Motor Control RFQ Questions

PREPARED BY RMM	DWG 11/19/97	 CUTLER-HAMMER CORPORATION MCC ASSEMBLY PLANT FAYETTEVILLE, NC	CHANGE 1	2	CHANGED STRUCTURE TO 4/23/98 P.S.P.E.
APPROVED BY FREEDOM 2100 MCC MCC CONDUIT SPACE	DWG		GENERAL ORDER NO. HBH49B74 -- 0013	1	2

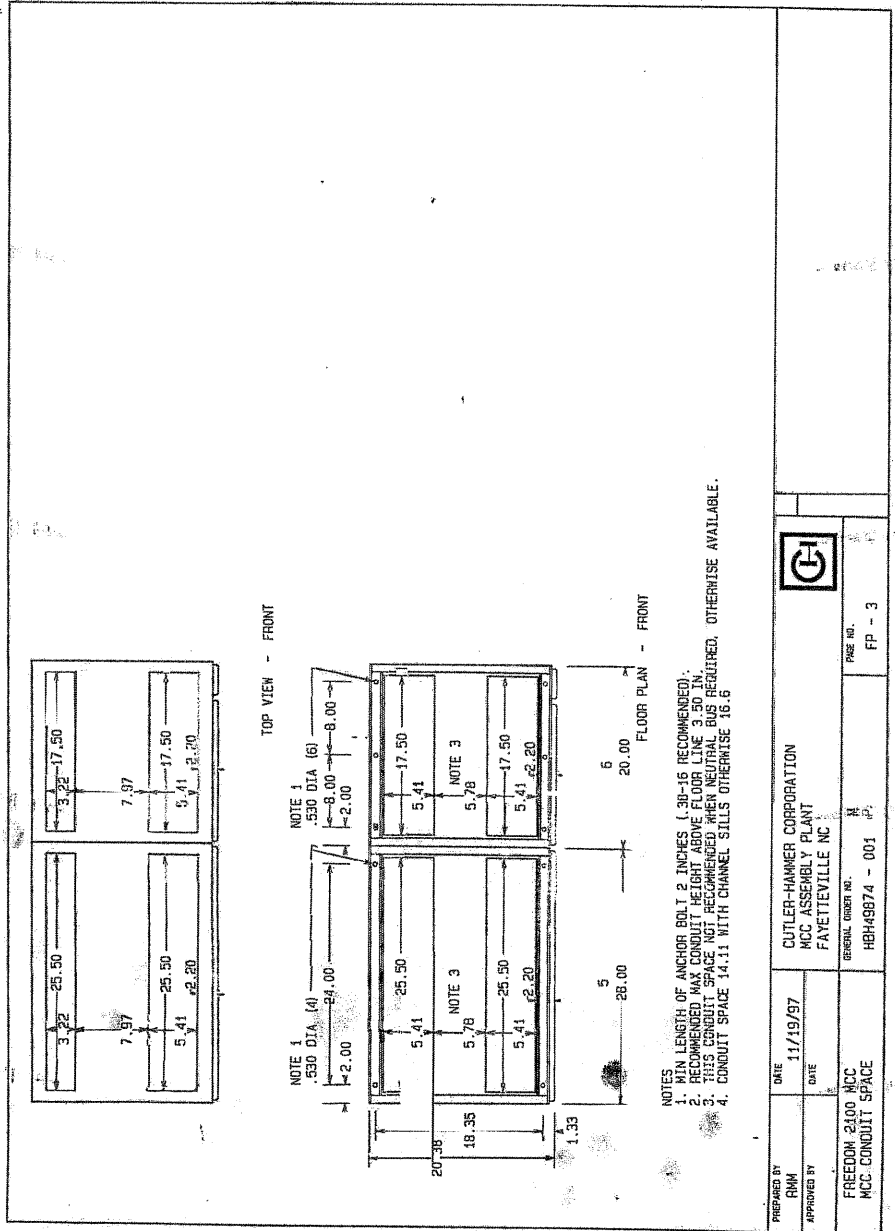
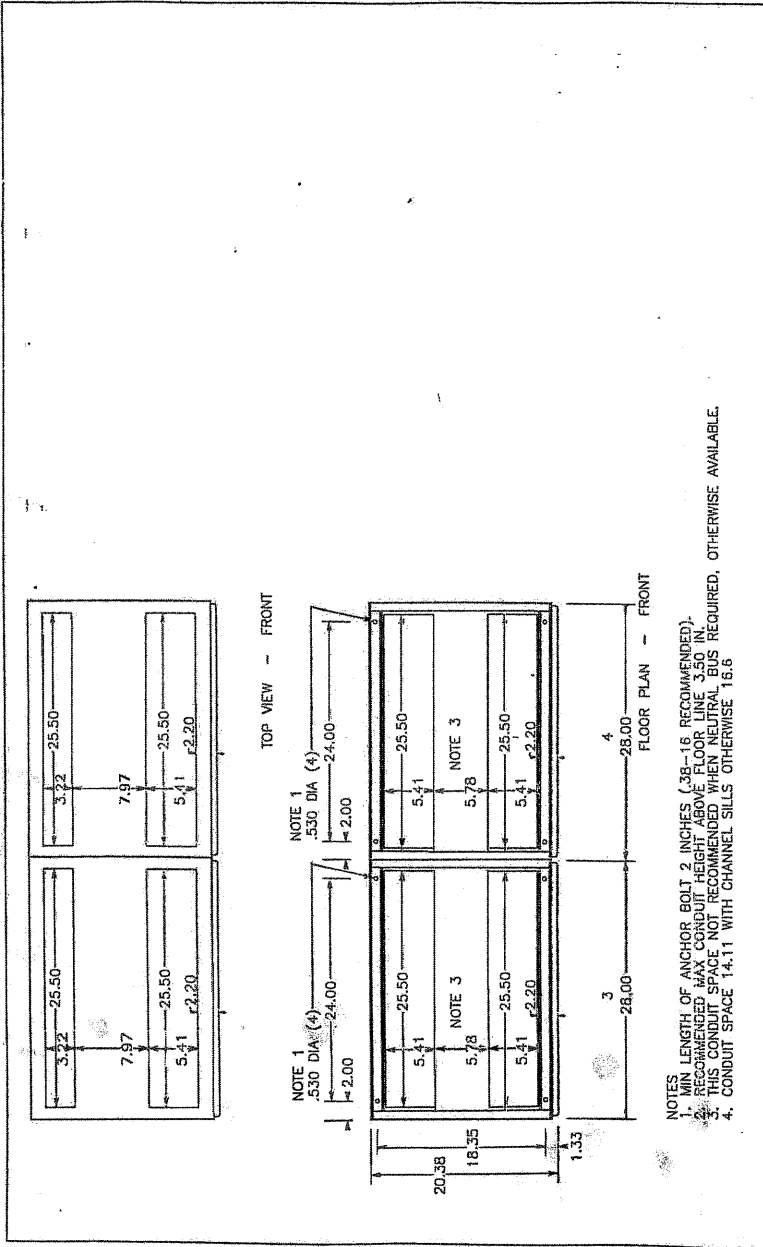
11. Question: What is the width, in inches, of the existing MCC? What is the current height of the existing MCC?

12. Question: Are the loads and feeders top-fed, bottom-fed, or a combination of both? Can we see a picture of the MCC with the doors open, or schedule a follow-up visit to open the doors?

Answer: **Information listed on the MCC documentation attachment.**

Answer: **Main power feed is bottom fed. Please see MCC documentation attachment.**
